# Rampion 2 Wind Farm

### Outline Construction Traffic Management Plan (clean)

**Date: August 2024**

**Revision G**

Figure 7.6.6c Local Access Routes

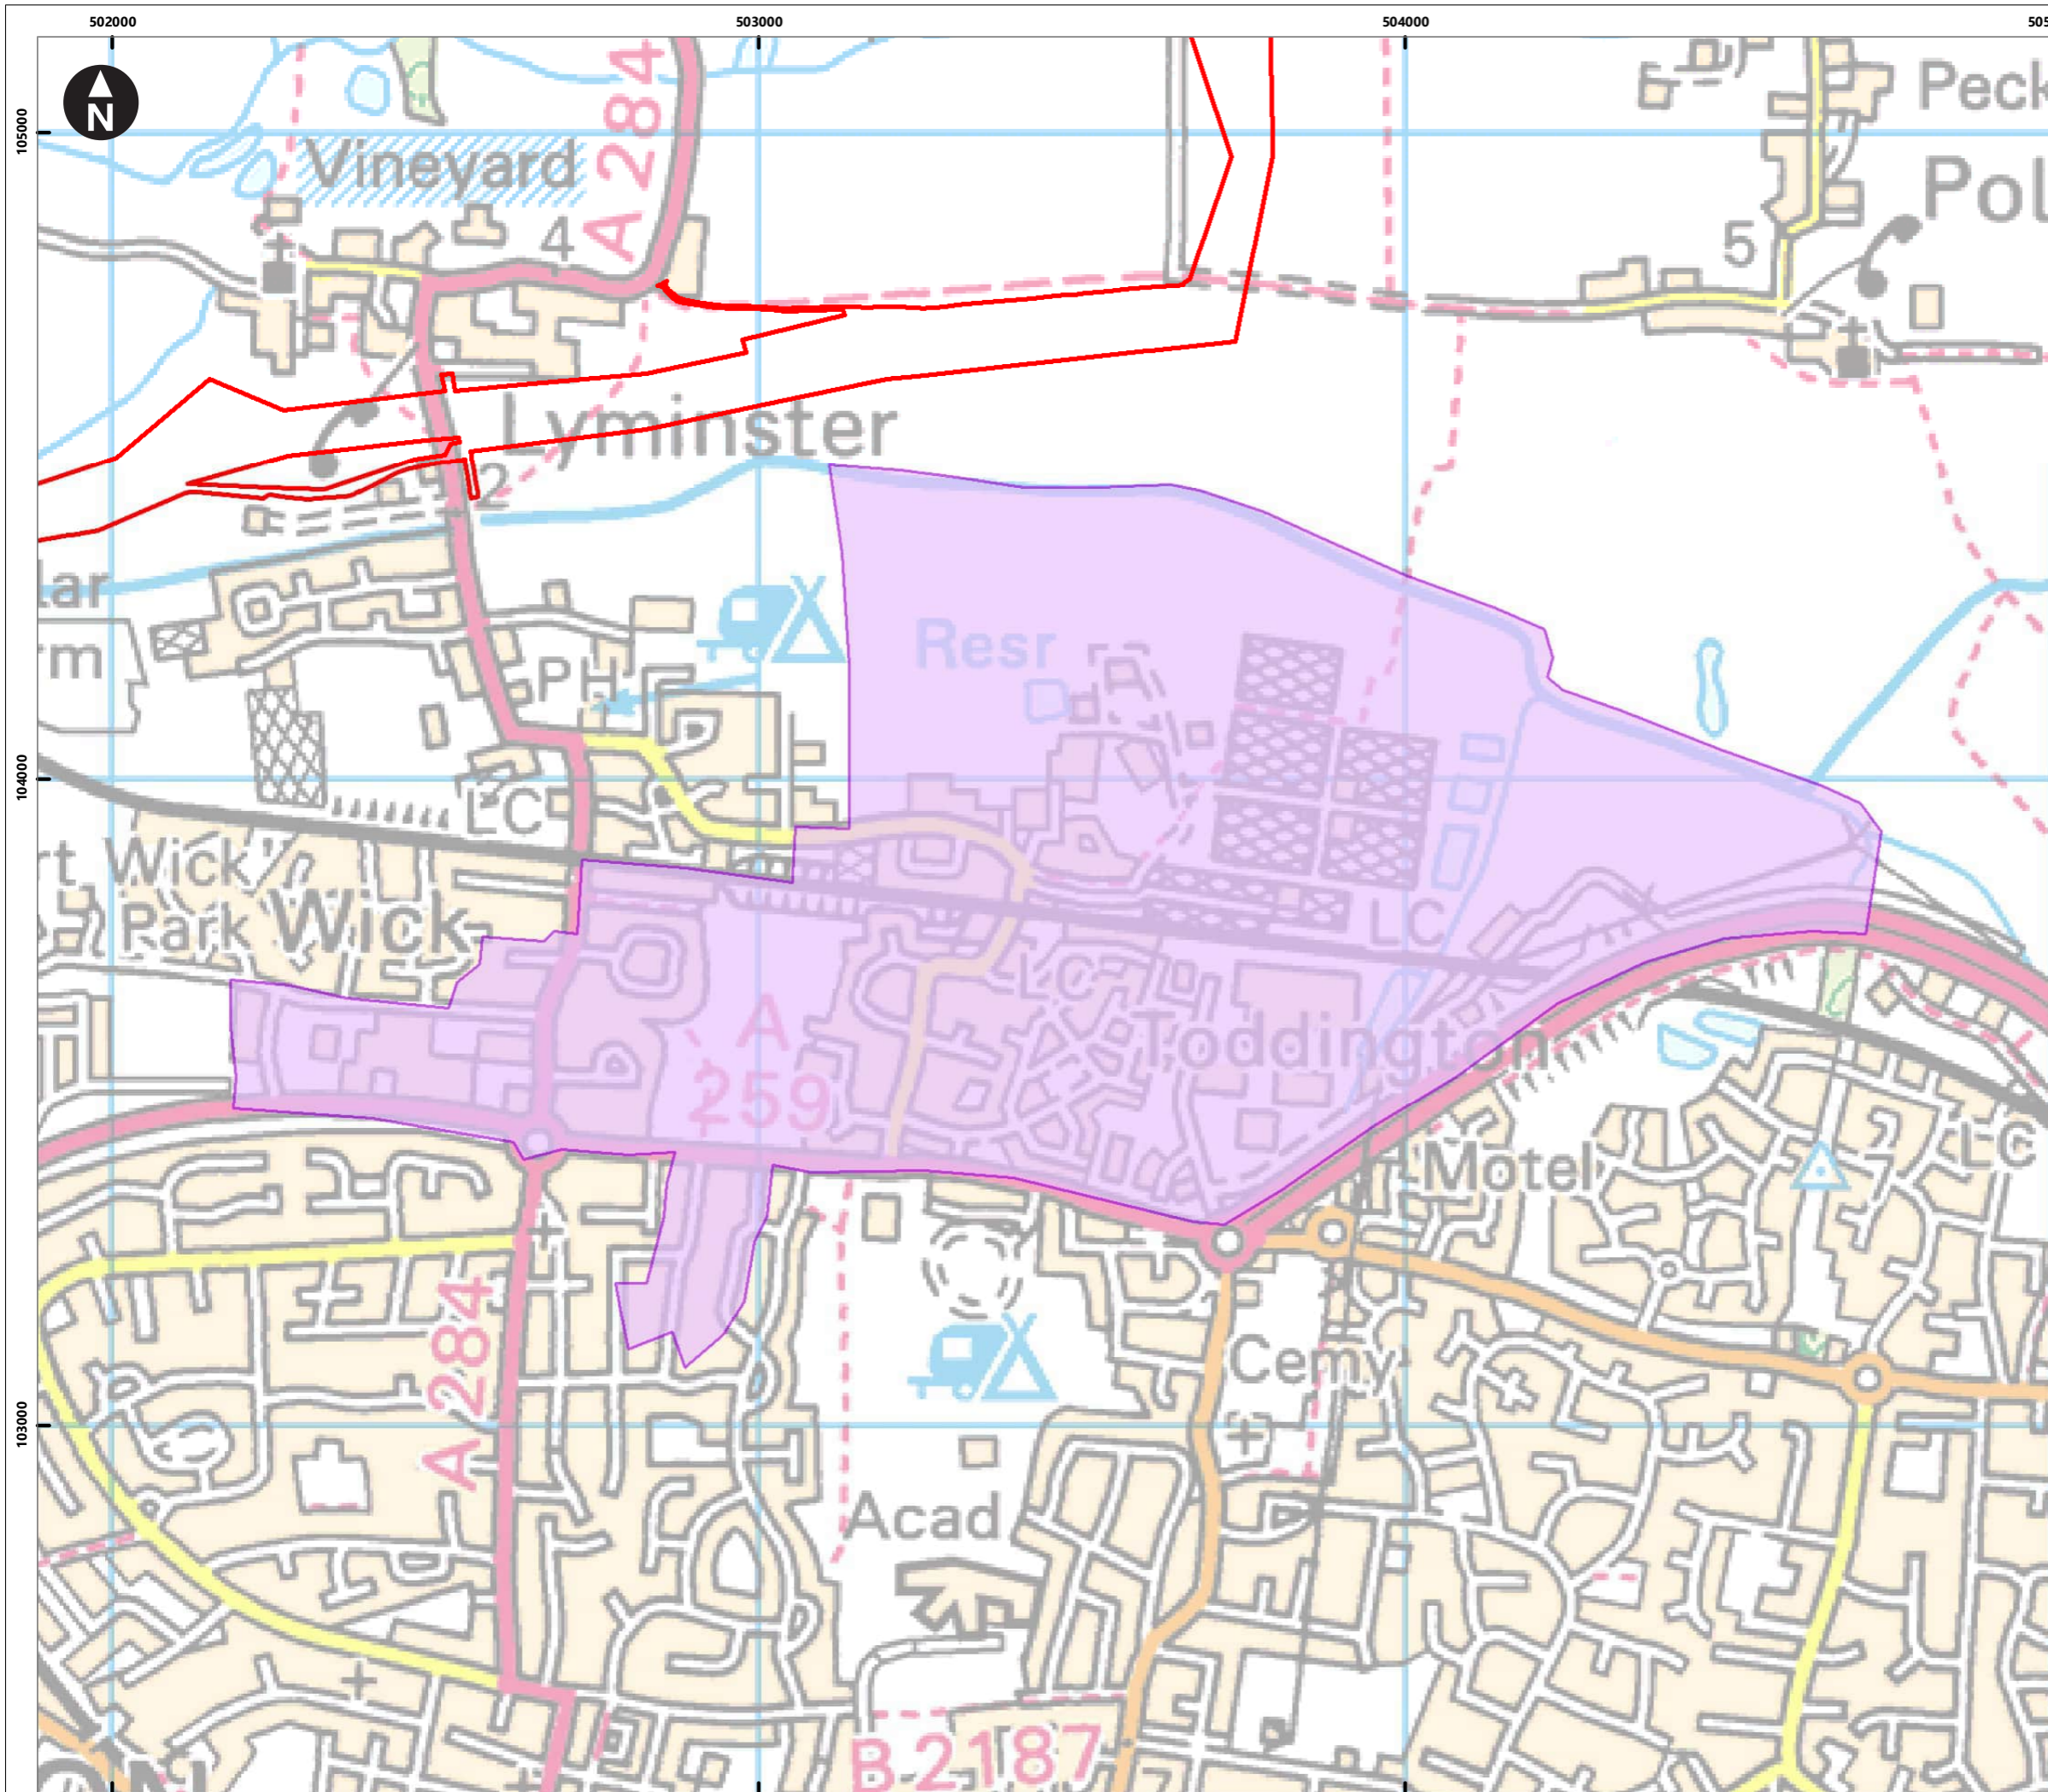
WSCC Local Impact Report Comment	Recommended Action	Applicant's Response to WSCC Local Impact Report	Applicant's amendment to the Outline CTMP
<p>Appendix B, Figure 7.6.6c The plan indicates HGV routing along the A272 through Cowfold from the west and using the A281 to the south. Some HGV activity through Cowfold is considered acceptable but in light of the Air Quality Management Area and existing traffic congestion, movements should be restricted. The majority of HGVs should arrive from the A23 to the east.</p>	<p>The plan should be updated to indicate HGV routing through Cowfold only where strictly necessary.</p>	<p>The Applicant will review this request and provide an update to the <b>Outline Construction Traffic Management Plan [REP1-010]</b> at Deadline 3 where appropriate</p>	<p>Additional text added to C-157 and C-158 to state that routing through Cowfold will only be for access A-56 and or A-57 or where use of locally sourced materials / equipment make its avoidance impracticable.</p> <p>In addition, vehicles restrictions are now proposed within <b>Paragraphs 8.4.18 to 8.4.21</b>. These will be implemented through the Delivery Management System and use of bookable delivery slots.</p>
